From: David Sellers
Sent: Wednesday, January 15, 2020 7:49 PM
To: Daniel S Imperiale
Cc: Ryan Hoest; Ryan Stroupe (R2S2@pge.com); stanford.rollins@1earth.ws; Knipfing, Isaac
Subject: RE: San Mateo CHW Diagram

Subject: San Mateo CHW Diagram

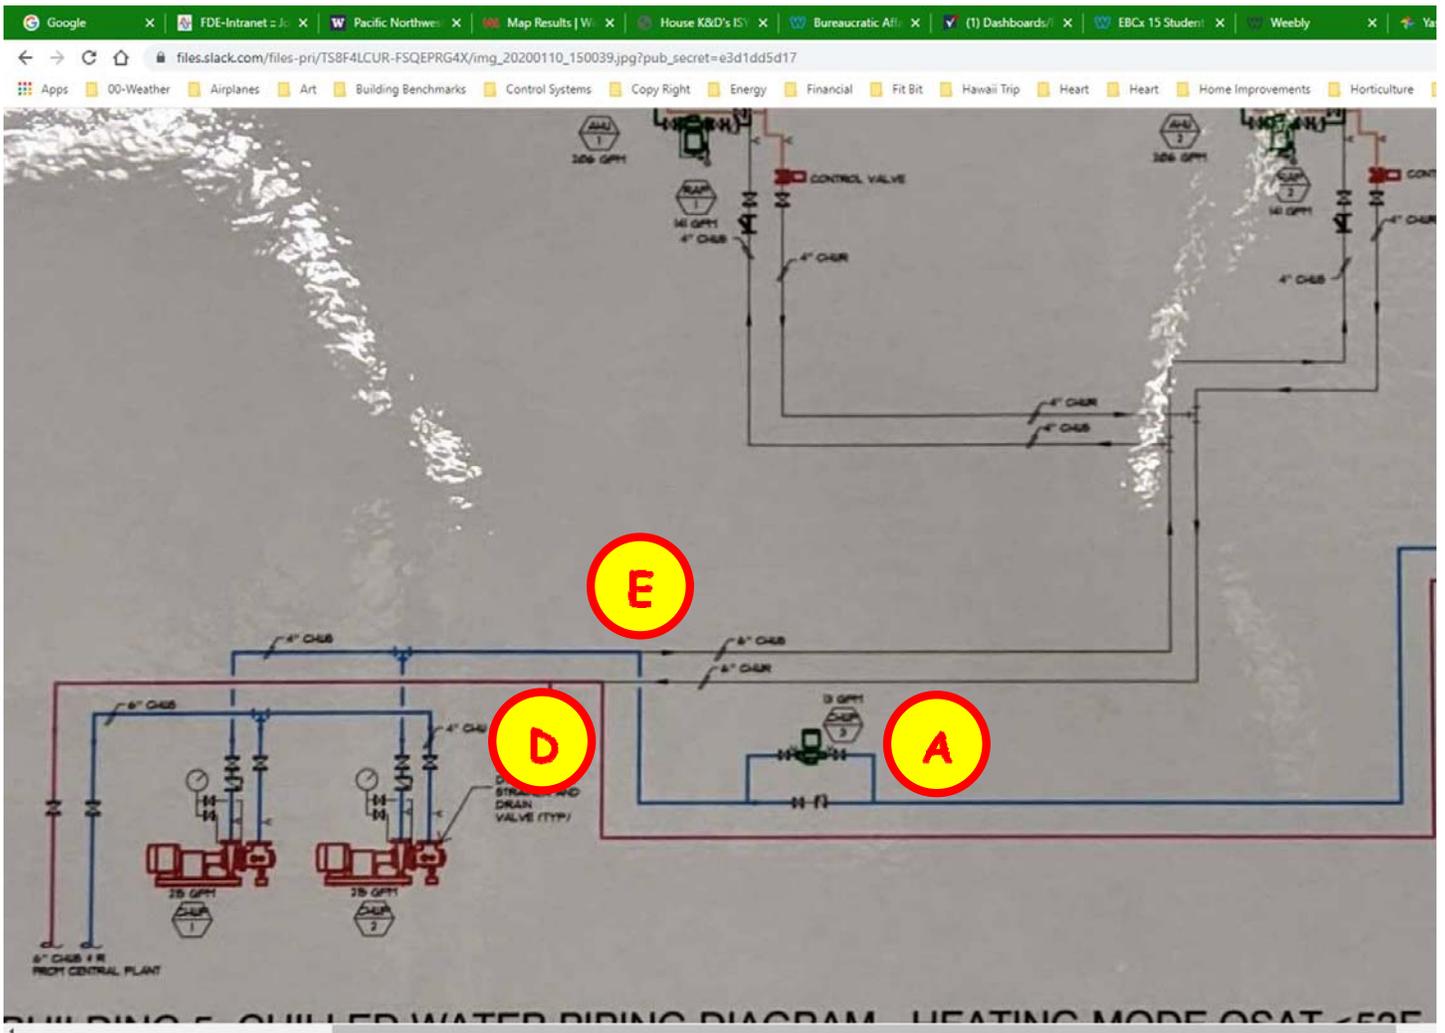
Ryan has asked me to do something with this in an upcoming EBCx class, so I will get into more depth in preparation for that. But for now, with regard to the last bullet point, I realize they might show what you say in their diagram. But sometimes, I have found that what is written down may not be what is actually happening.

In situations like that I try to go back to fundamental principles and in this case, my conclusion is based on conservation of mass as follows.

I should also mention at the end of the day, the building probably was telling us the answer; we (or at least I) forgot to see what it had to say. In other words, if the pipes at the remote location are cold/at or near the CHW supply temperature, then there is flow. If there really is no flow, then the lines would warm up.

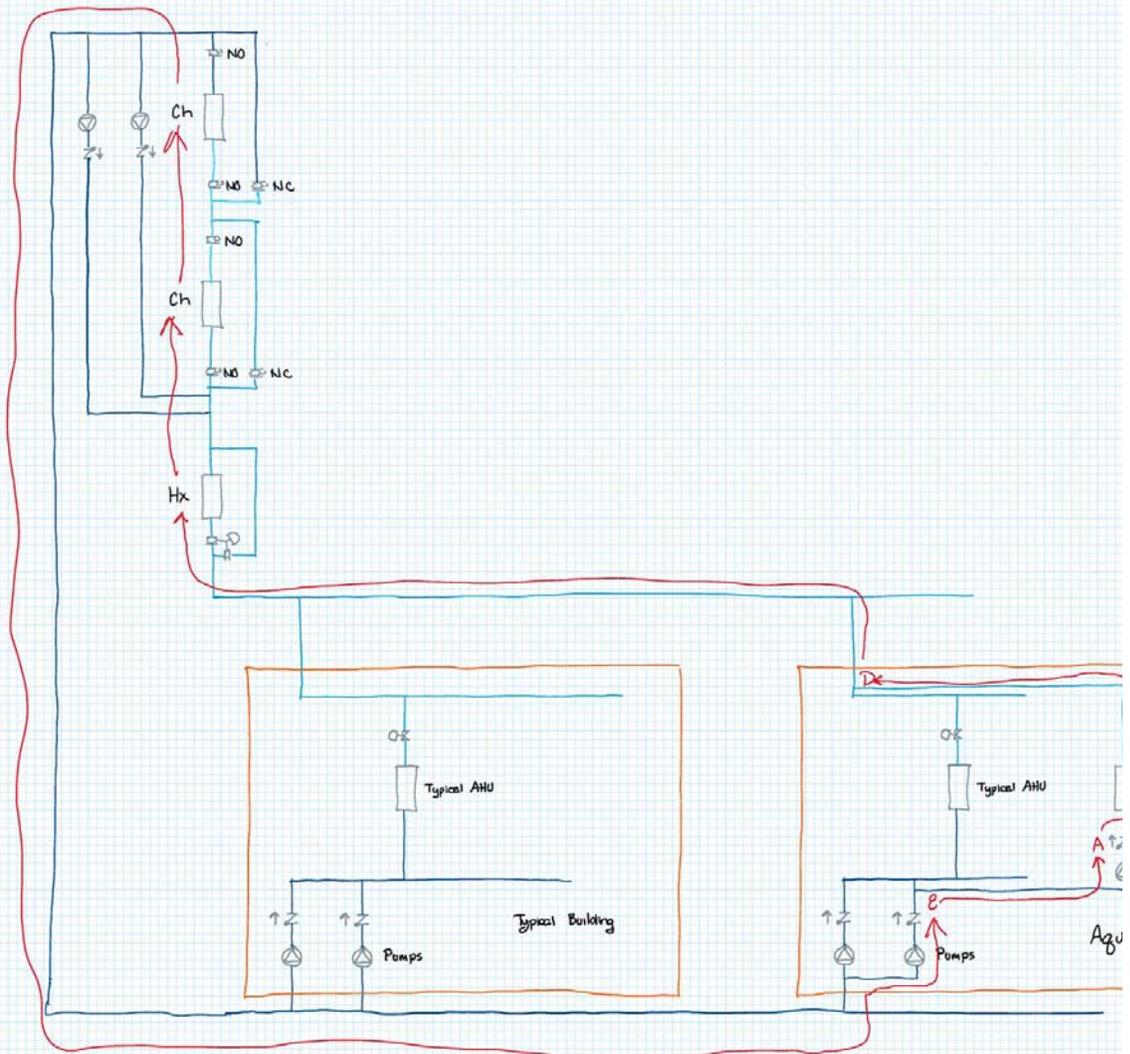
1. If we start at "A" and assume the fan coil unit valve is open and the pump is running, then, if I am thinking about it right, the water would want to flow from A to B to C and then back to the mains at D.

2. To conserve mass, from D, the water would have to get back to E somehow. This is where my diagram might come in handy

- There are two options I think. One route would be to flow back to the plant, go through the plant and come back as cold water, flow through one or both pumps, lift their check valves, and return to E and then to the booster pump suction and back to A, the booster pump discharge.

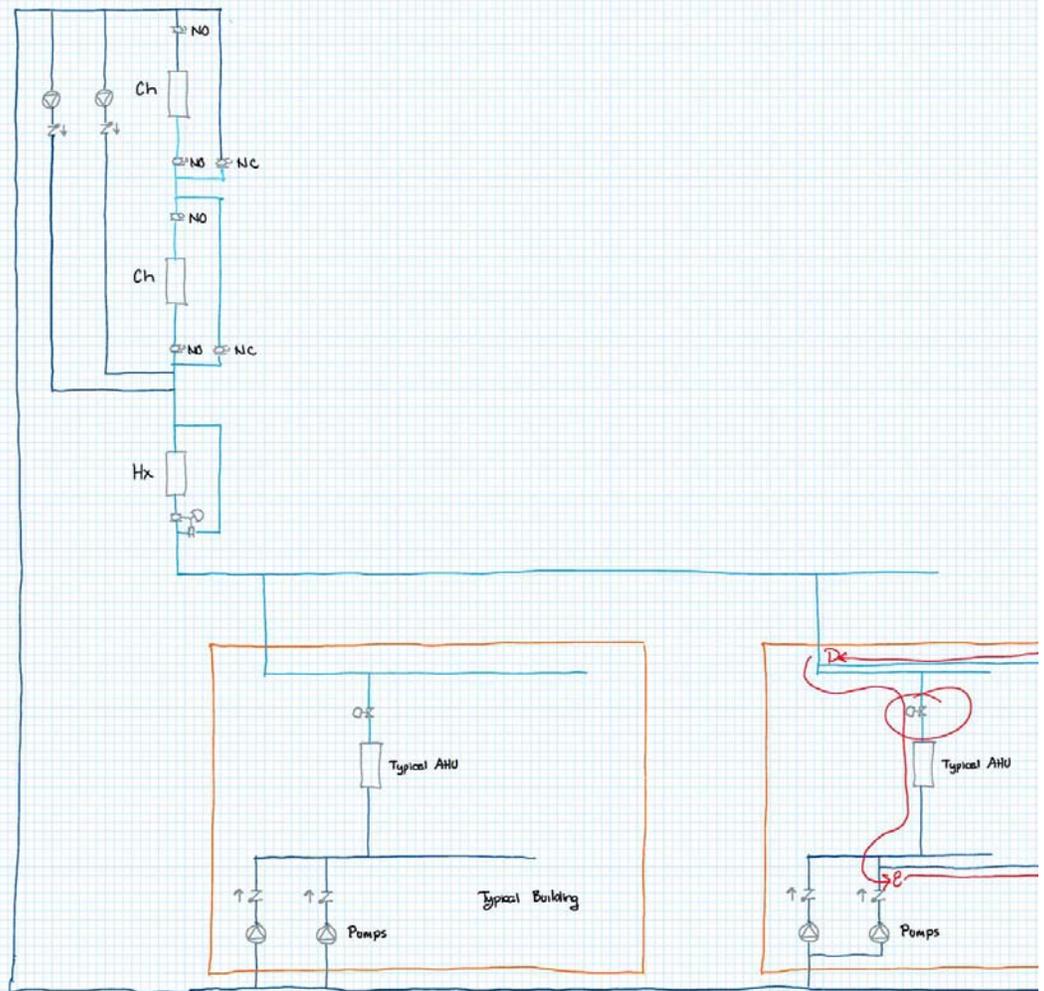
But with out the primary pumps, it means the booster pump would need to have enough head "compete" with the building pumps in the other buildings if they were running. That is because the booster pump would be in parallel with them through the load and through the aquatic center building pumps. In other words, it's suction connection traces back to the same pipe as the suction connection of the other building pumps, and its discharge connection also traces to the same pipe as the discharge connection of the building pumps.

In addition, it would have to have enough head to lift the check valves on the primary pumps. This is probably less of an issue than competing with other, potentially higher head pumps in parallel with it. But, most check valves rely on more than differential pressure and/or gravity to close in order to ensure that they close before flow reversal happens. That means most of them have springs that force the discs closed. That means that before the valve opens the pump has to generate enough pressure to overcome the spring forces. I believe the spring force is not particularly huge, maybe 0.5 - 1 psig (1-2 ft.w.c.). But it could be a factor for a pump selected for a relatively low head, which is typically what booster pumps are picked to do.

I don't know the booster pump's rating but it would not surprise me if one or the other of the items I just mentioned was a constraint. For instance, if the other building pumps were creating a head of 50 ft.w.c. across the mains to/from the plant, the booster pump would need to have that much head available between D and E to push water into the system along with whatever head it took to move the required flow for the fan coil unit through the circuit it served, which would include the primary pump check valves, pump bodies and piping if the primary pumps were off.

And, if the flow was occurring on this route, then it would go by the flow sensor for the BTU meter, which appeared to be located in the common piping just outside the pump room (kind of where the orange "building" line crosses the dark blue CHW line ahead of the building pumps). So, if there was flow in this line and it was above the cut-in point for the flow meter, then it should have shown up as flow on the meter.
